PACKARD MOTOR CAR COMPANY

October 19, 1929

To: Packard Distributors and Dealers

Subject: SHOCK ABSORBER FILLER PLUG

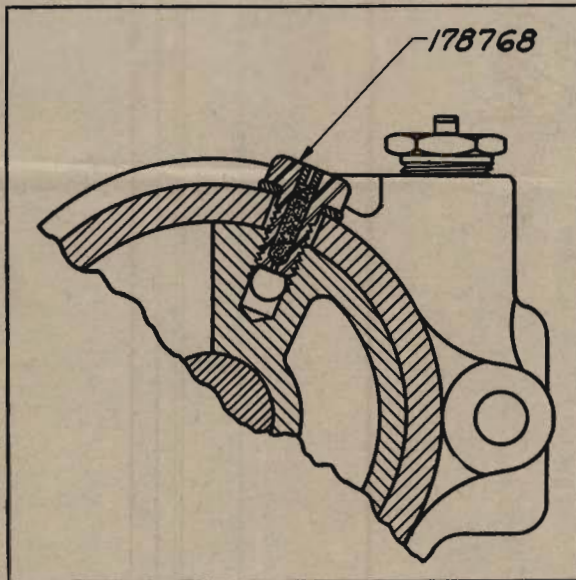
A change has been made in the shock absorber filler plug, and the new construction is shown in the illustration.

The new filler plug provides a vent for the reserve chamber through a small hole, and the center of the plug has been bored out and filled with a felt packing to prevent dirt or water from entering the shock absorber.

We have found that by thus directly venting the reserve chamber, that leakage at the packing gland and around the metering valve is prevented. Insufficient venting has caused leakage due to expansion of the oil from the high temperatures set up in the shock absorber when it was worked hard. The excess oil caused by expansion will now find its way out through the small hole in the new filler plug, but as soon as the maximum expansion has occurred, the leakage at this point will cease. The new plug also prevents the oil in the working chamber from

becoming charged with air and changing the action of the absorber, as has sometimes happened.

This change applies to all Packard hydraulic shock absorbers and we suggest that as cars enter your service station a check be made to determine whether they are equipped with the new plugs. If you find that this is not the case, the shock absorbers should be filled with oil and the new plugs installed. They may be identified by the small hole in the center of the head.

4—178768 Shock Absorber Housing Filler Screw Assemblies.
